CONSTRUCTION DOCUMENTS FOR:
HAVEN VALLEY
 (LETA DR.) BRADLEY RD/ALTURAS DR.
 SECURITY, EL PASO COUNTY, COLORADO

v1_Construction Drawings.pdf Markup Summary 10-19-2023

OUT1

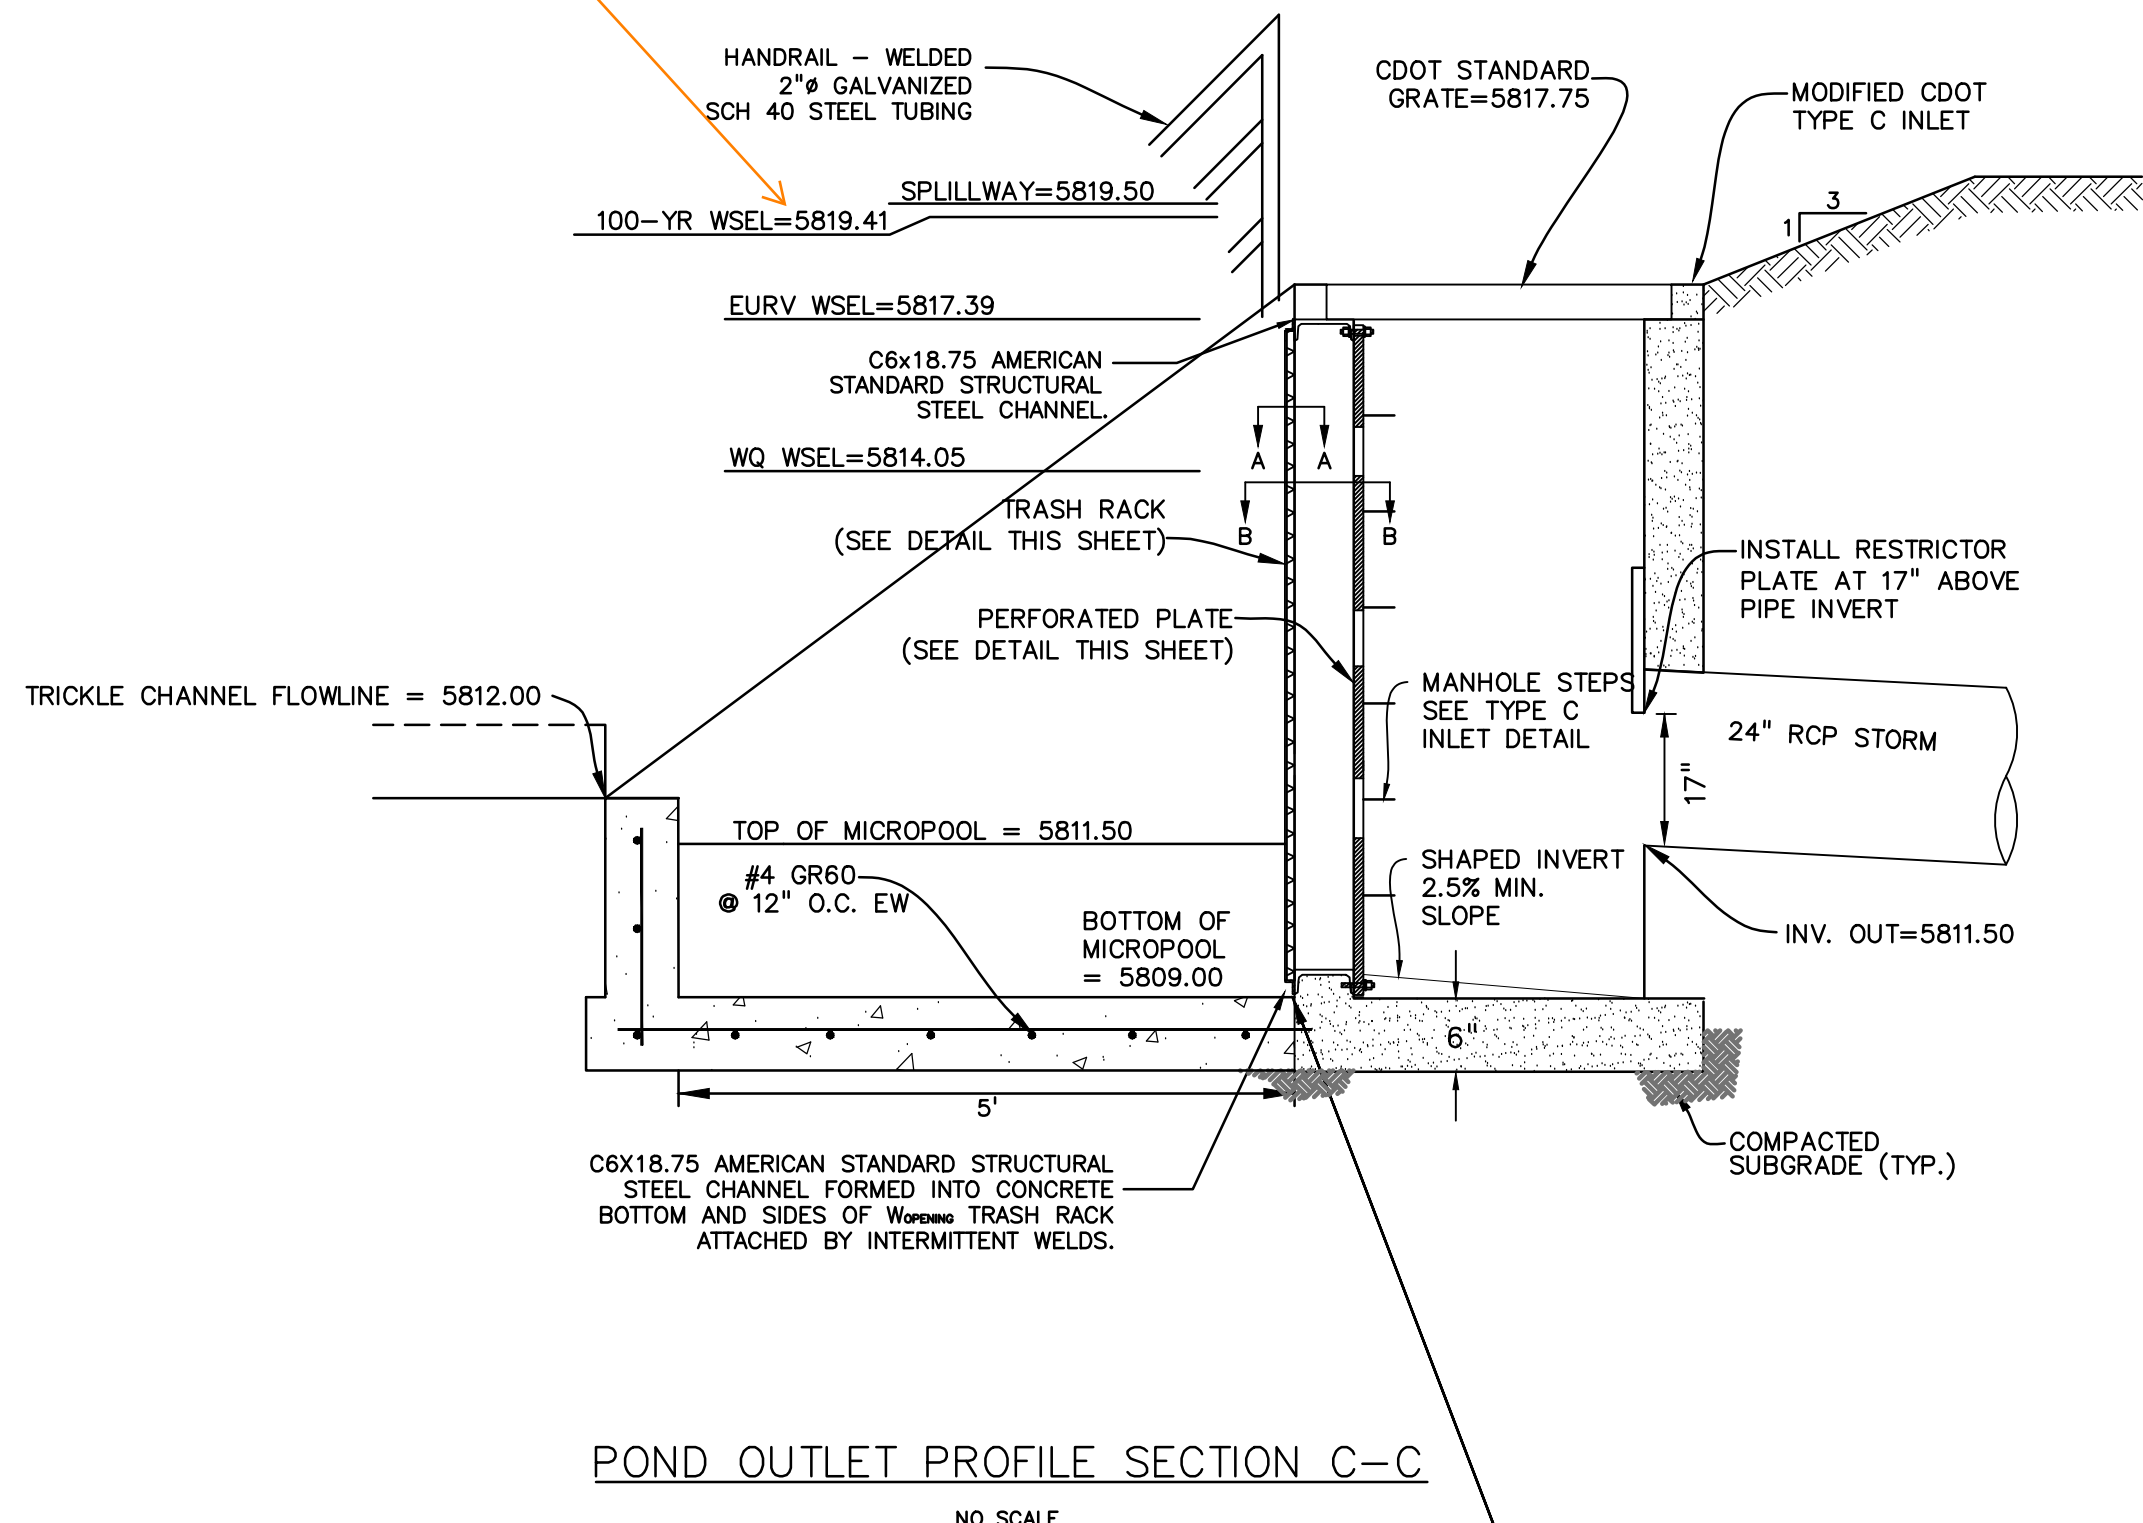
The 100-yr depth is 5818.95 based on the MHFD-Detention spreadsheet on PDF page 68 of 76 of the FDR (ponding depth of 7.45ft above Stage=0ft which is at 5811.50).
